Sundry Notices and Reports on Wells	
~ 5	. Lease Number MOO-C-1420-0625
1. Type of Well 6	. If Indian, All. or
GAS	Tribe Name
7	. Unit Agreement Name
2. Name of Operator	
BURLINGTON	
RESOURCES OIL & GAS COMPANY LP

3. Address & Phone No. of Operator	. Well Name & Number Pinon Mesa B #1
PO Box 4289, Farmington, NM 87499 (505) 326-9700 9	. API Well No.
FO BOX 4209, Parketington, NM 07499 (300) 320-3700	30-045-21608

# Pinon Mesa B #1 -- Dakota PLUG AND ABANDONMENT PROCEDURE

### Conditions of Approval - Notice of Intent to Abandon

## Pinon Mesa B #1

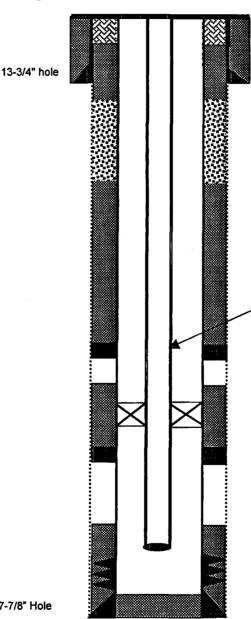
- 5d. The volume of Plug #5 (Surface plug) must be increased. The plug shall be of a sufficient volume to fill the casing from 460' to the surface. The additional volume will ensure coverage across two squeeze perforations and to cover the annular area that was the subject of the two squeeze cement jobs.

- 6. The well must be filled with a wellbore fluid sufficient to stabilize the wellbore. In the absence of any formation pressure data provided by the operator, this fluid will have a minimum weight of **9 ppg**. The fluid must be left between all plugs.
